SUBJECT: Forwards response to Item 3 of Commission May 1979 orders re noncondensable gases.

Re: Oconee Nuclear Station
Docket Nos. 50-269, -270, -287

Question 3 - Noncondensable Gases

FIGURE 1

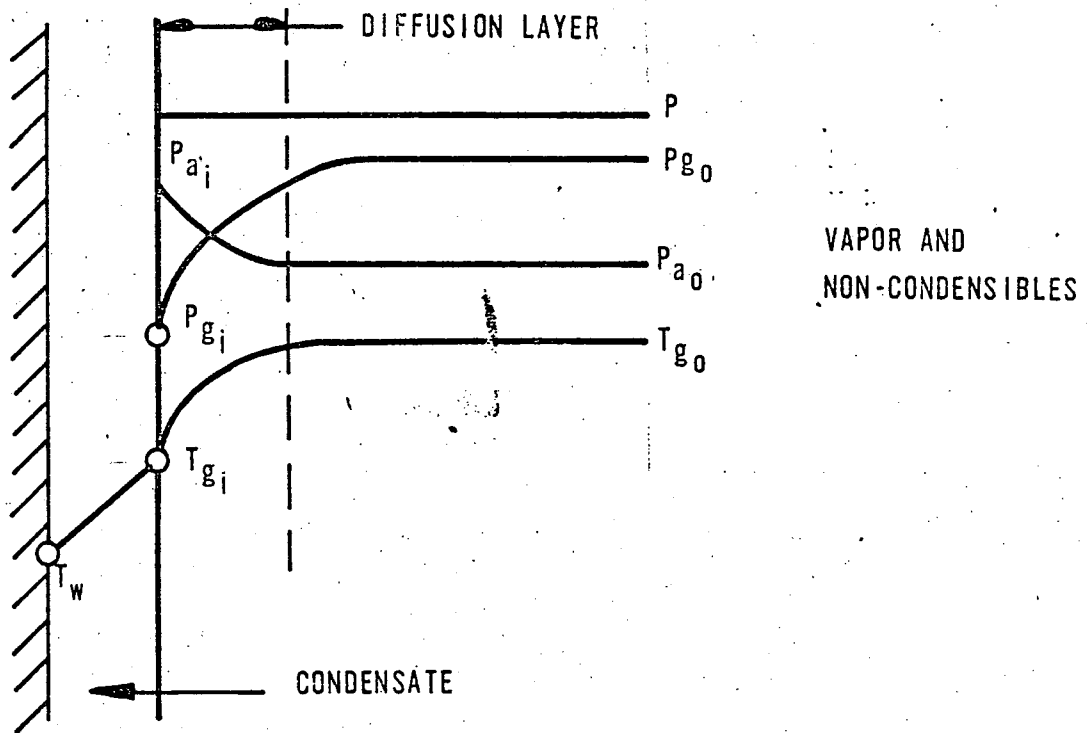
The heat transfer during condensation is made up of the sensible heat transferred through the diffusion layer and the latent heat released due to condensation of the vapor reaching the interface (see Figure 1). The model of Colburn and Hougen⁽¹⁾ gives the following equation for the heat transfer in the vapor phase:
